Community and Stakeholder Engagement Report

Addiscombe Road and Kenneth Road, Manly Vale – Shared Path and Pedestrian Crossing Upgrade

New concrete island on Addiscombe Rd at the intersection of Kenneth Road:

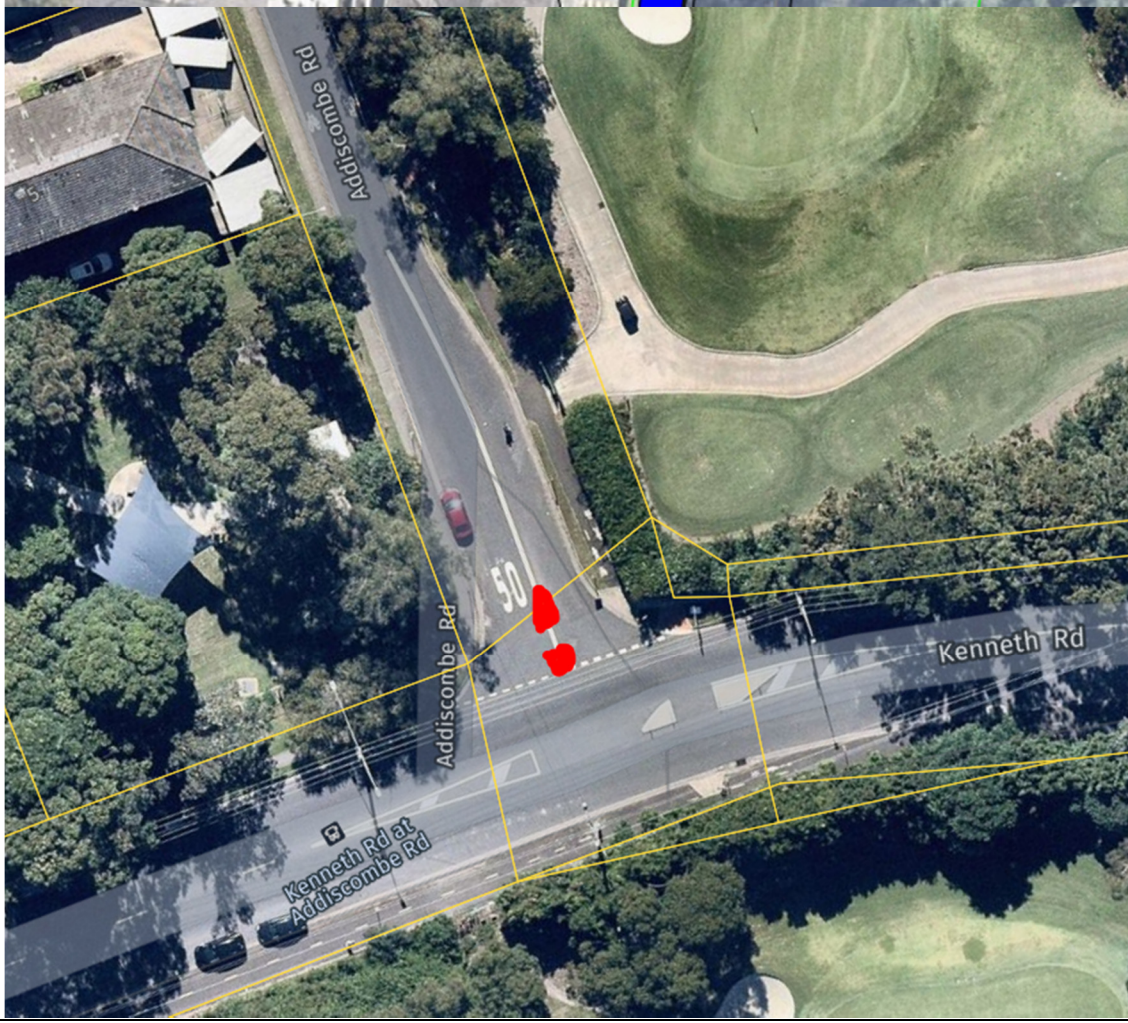
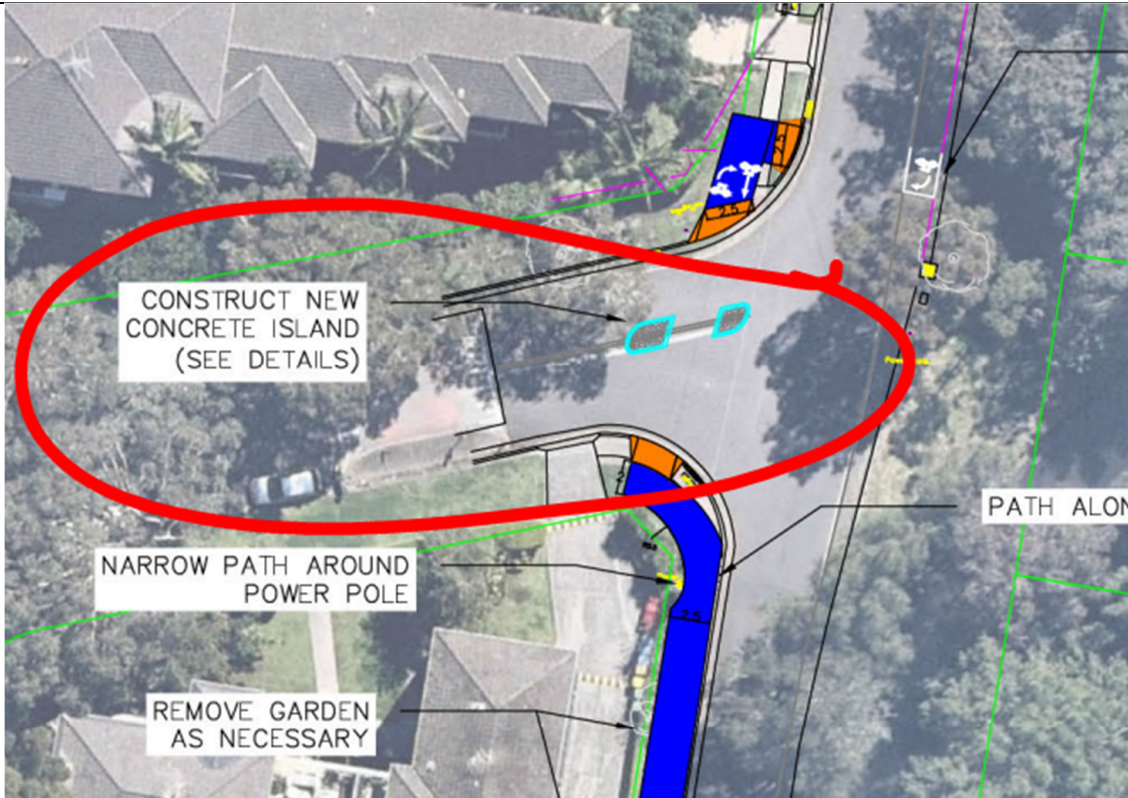
- An issue that I have raised with Council in the past is the use of Addiscombe as a U-turn bay for road users who do not get a parking spot along the Boy Charlton / Graham Reserve parking spaces and need to try the other side of the road. This is extremely unsafe all vehicles, pedestrians and cyclists, particularly school students who have been in accidents at this intersection and many near-miss accidents.
- Propose adding a concrete island to this location, similar to the island proposed on Fairway Close at the intersection with Addiscombe Rd, allowing pedestrians to cross safely and deter vehicles from the frequent U-turn

Widen proposed shared path with a slight shift of the Council shed:

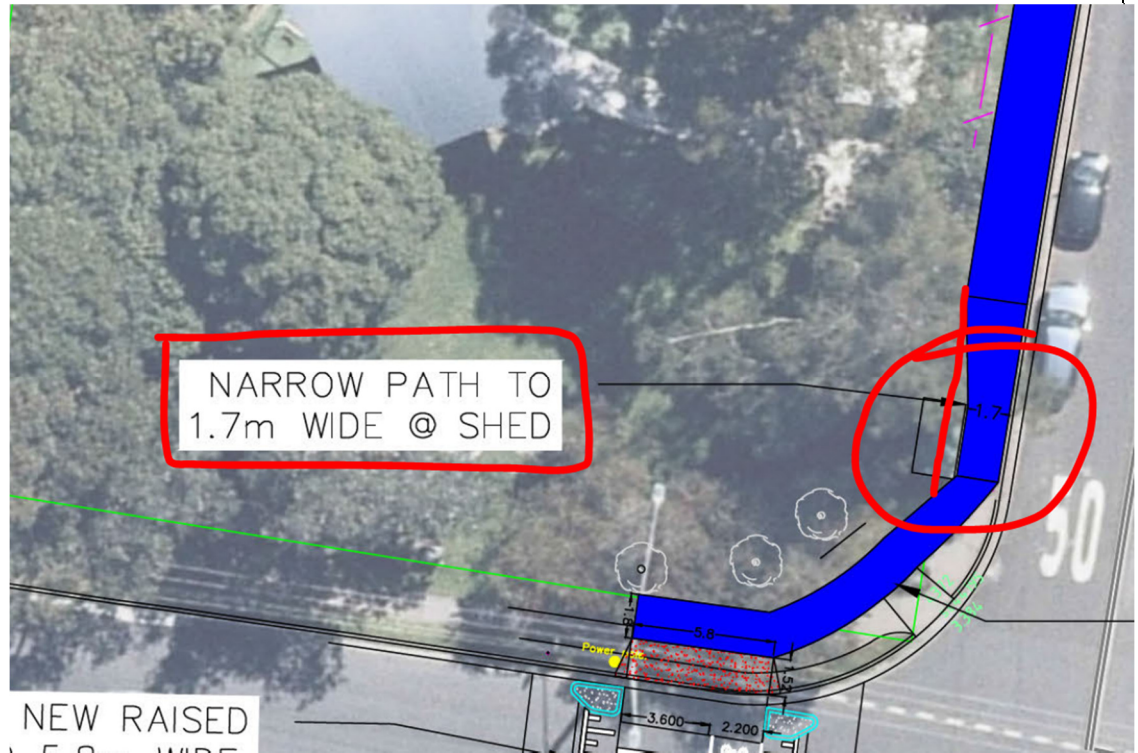
- No need to create an unsafe narrow section of path right at the intersection of Kenneth Road. Narrowing the path in this location is unnecessary when there is plenty of room to shift the shed towards Fairway Reserve. A newly planned path can accommodate the full width of a shared path at this location and should not be compromised because of Council's recent placement of this shed.
